**1 REVISED PER ADDENDUM No. 1 DATED JANUARY 27, 2011**

DESIGN BY <i>Jim Torkelson</i> CHECKED <i>Tech Ngov</i>	STATE OF CALIFORNIA DEPARTMENT OF TRANSPORTATION	DIVISION OF ENGINEERING SERVICES	BRIDGE NO. 49M5506	<b>DISTRICT 5 MAIN OFFICE PHOTOVOLTAIC SYSTEM</b> PARTIAL SITE PLAN AND ROOF PLAN	SHEET EE-1
DETAILS BY <i>J. Kwong/L. Monson</i> CHECKED <i>Tech Ngov</i>		ELECTRICAL-MECHANICAL-WATER AND WASTEWATER DESIGN	POST MILE		
QUANTITIES BY <i>Jim Torkelson</i> CHECKED <i>Alan Torres</i>		UNIT PROJECT NUMBER & PHASE 1221 05000202351	DISREGARD PRINTS BEARING EARLIER REVISION DATES		REVISION DATES (PRELIMINARY STAGE ONLY)

DESIGN BY: JIm Torkelson	CHECKED: Tech Ngov	STATE OF CALIFORNIA DEPARTMENT OF TRANSPORTATION	DIVISION OF ENGINEERING SERVICES ELECTRICAL-MECHANICAL-WATER AND WASTEWATER DESIGN	BRIDGE NO. 49M5506	DISTRICT 5 MAIN OFFICE PHOTOVOLTAIC SYSTEM	SHEET EE-2
				POST MILE		
DETAILS BY: J. Kwong/L. Monson	CHECKED: Tech Ngov	ORIGINAL SCALE IN INCHES FOR REDUCED PLANS: 0 1 2 3	UNIT PROJECT NUMBER & PHASE: 1221 05000202351	DISREGARD PRINTS BEARING EARLIER REVISION DATES	REVISION DATES (PRELIMINARY STAGE ONLY): 1/17/09 1/26/10	SHEET OF
QUANTITIES BY: JIm Torkelson	CHECKED: Alan

**PHOTOVOLTAIC SYSTEM**

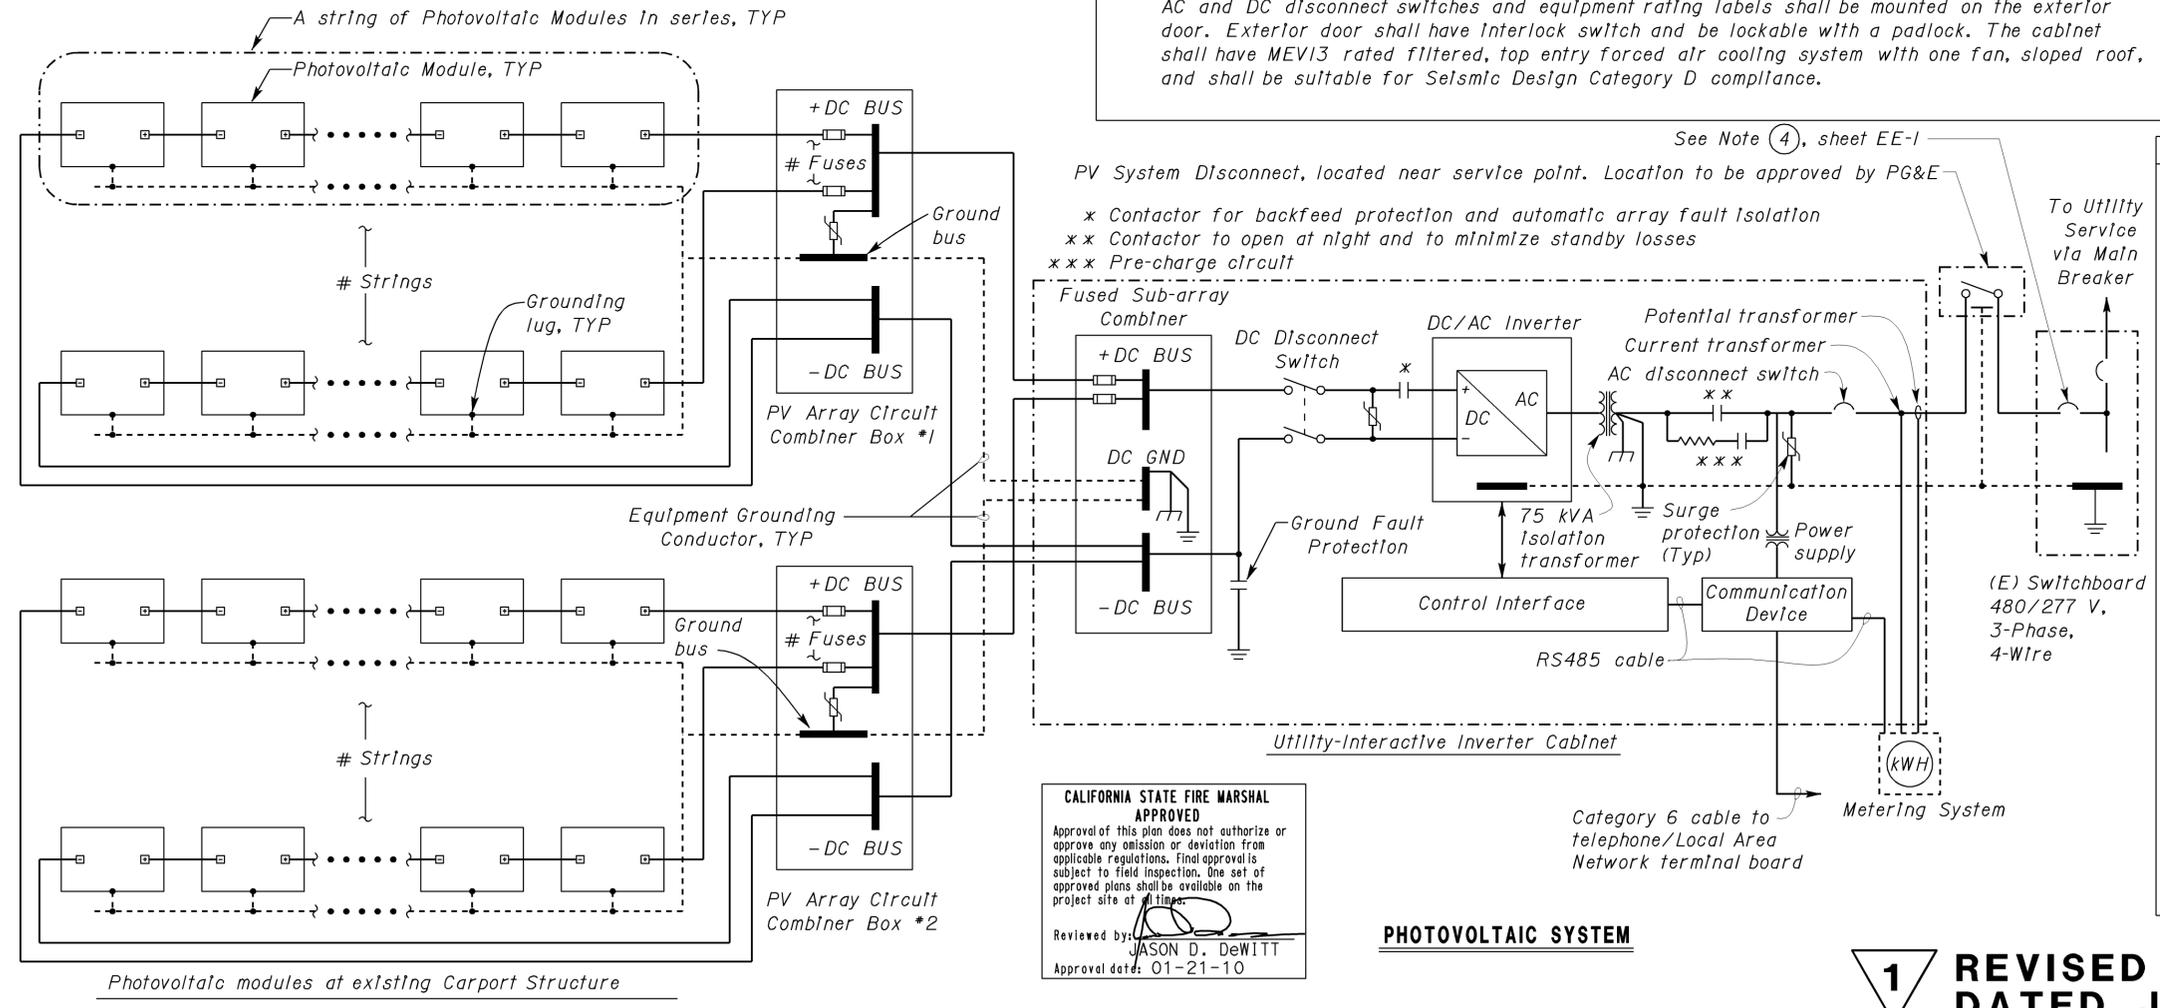
**REVISED PER ADDENDUM No. 1 DATED JANUARY 27, 2011**
